Switching Programme Change Request Form

Decommissioning of Existing (SEC) Registration Data Provider Communication Links

Change request No.	CR-E24	Date CR submitted	08/11/18
Change request status:	Submitted to DF	Current CR version:	0.4
Change Window:	10	Version date:	07/01/19

Figure 1: Solution at CSS Go-Live

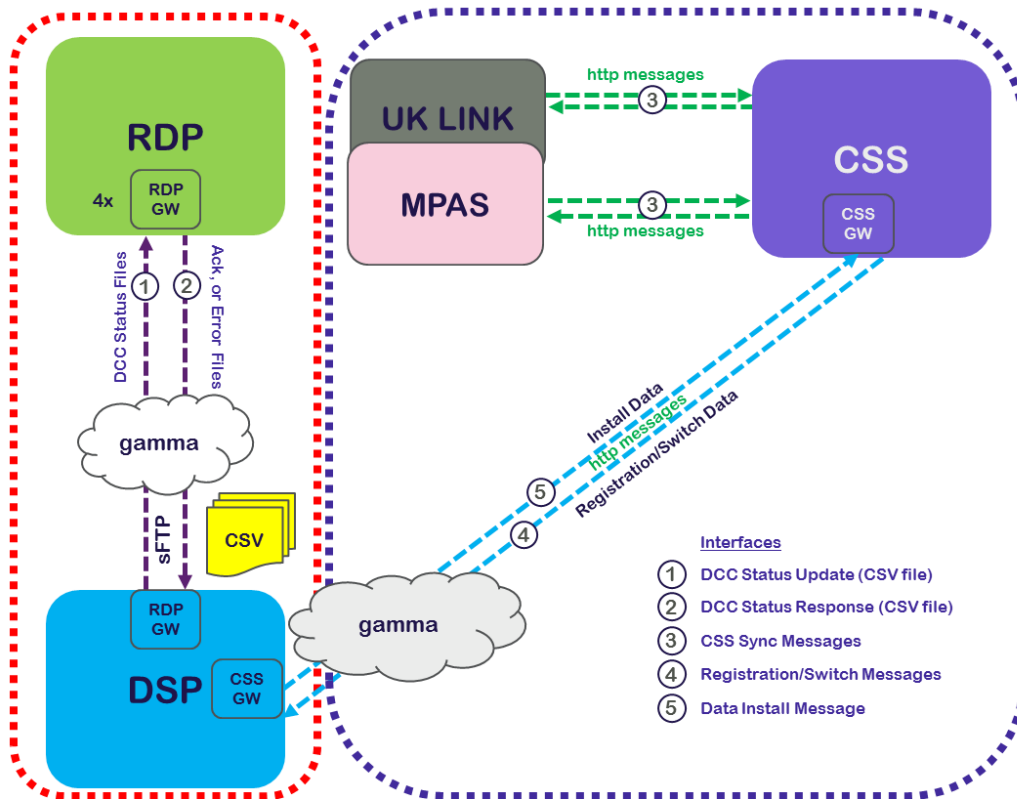
As a consequence the dataflow from RDP to DSP will become redundant. However, DSP to RDP flow will remain unchanged resulting in the architecture highlighted in figure 1 below.

Figure 2: Proposed Solution

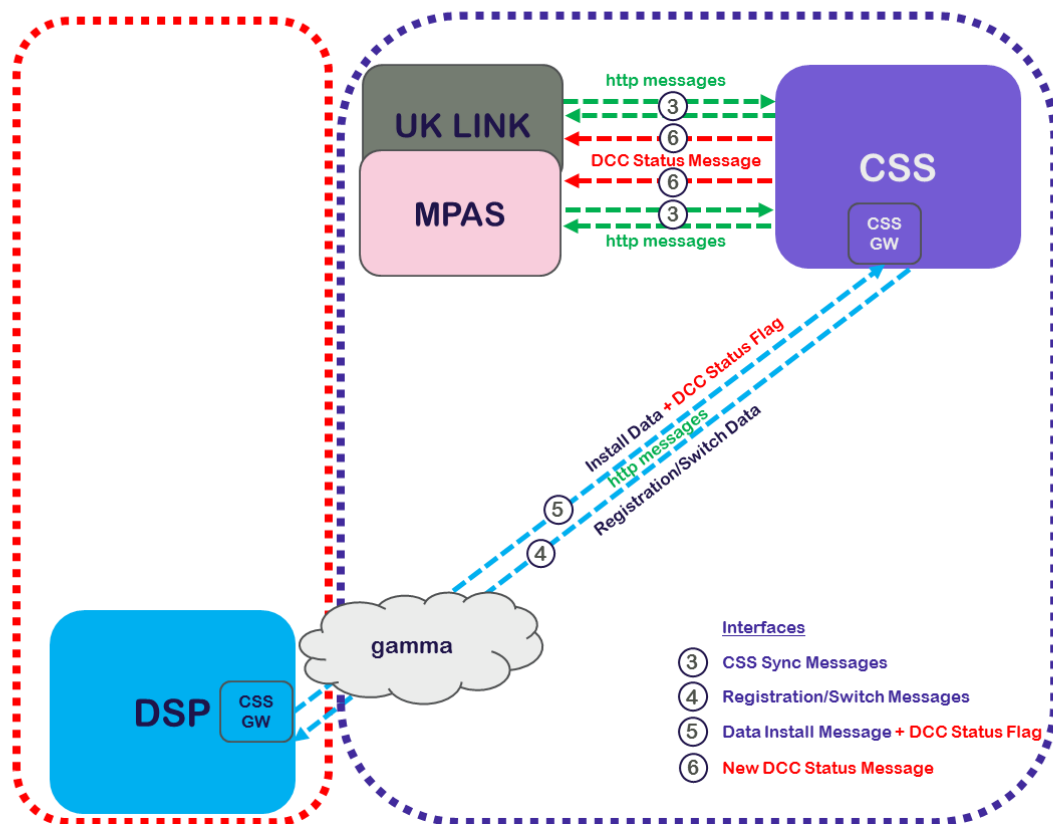
This change request (CR) proposes that the new CSS will provide capability to transfer DSP data to the current RDP, or their successors on a regular basis, once it has become operational as highlighted in figure 2 below.

1. It is assumed in this CR that the DCC Status Update information only needs to be provided to UK Link and MPAS and not directly to the original RDPs. If this is not the case, then additional communication links to provide the DCC Update will be required between UK Link and MPAS to four RDPs, and these additional connections will need to be included in the impact assessments

2. The DCC Status Update information will be sent from the DSP to the CSS by extending the Install Data message with two additional attributes (DCC Status Flag and Effective from Date), while the remaining status update information is already included in the Install Data message

3. The CSS will perform parameter validation on the Install Data message to ensure all attributes are in the correct format, contain valid values and in the case of Supply Meter Point Reference Number/MPAN Core are valid entries. This will avoid the requirement for MPAS and UK Link to provide acknowledgement, or error responses back to the DSP

4. The CSS will send a new DCC Status Update message over the existing CSS to MPAS/UK Link http connection and this message will contain the same information that was previously provided via the original DSP CSV files

5. The new DSP Status Update messages will be delivered as the status changes occur and will not be packaged as a batch of changes. It will then be the responsibility of MPAS and UK Link to determine how the information then is managed and forwarded within their systems
